**Service information**

**Reference no.: SDA\_109932**

Keyboard OXI in GranBaristo and GranBaristo Avanti.

Image1

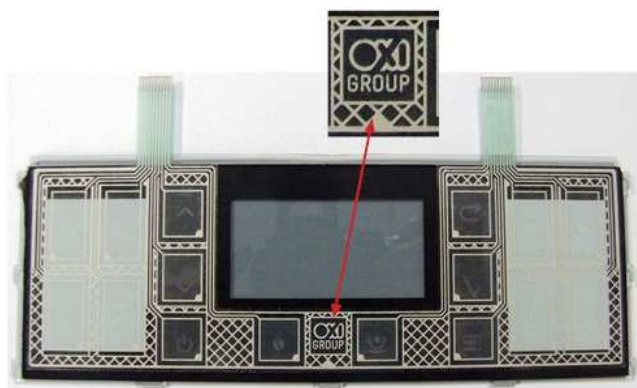
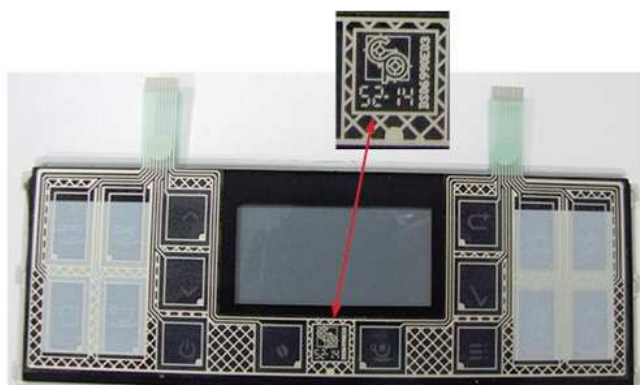
**INFO:**  
Potential problematic feature keyboards OXI.

**CURE:**  
If the customer claims a functional problem of the keys, even if it is not identified by service during repair check, if a keyboard is mounted supplier OXI (image1),

and replace it with that of the supplier Crosspoint (image2).

The spare parts department have in stock only the keyboard supplier Crosspoint.  
GranBaristo Avanti cod. 421944033481 TRANSP.FRONT CASING S/SCR.V2 CST ASSY  
GranBaristo cod. 421941301281 TRANSP.FRONT CASING S/SCR.CST ASSY.
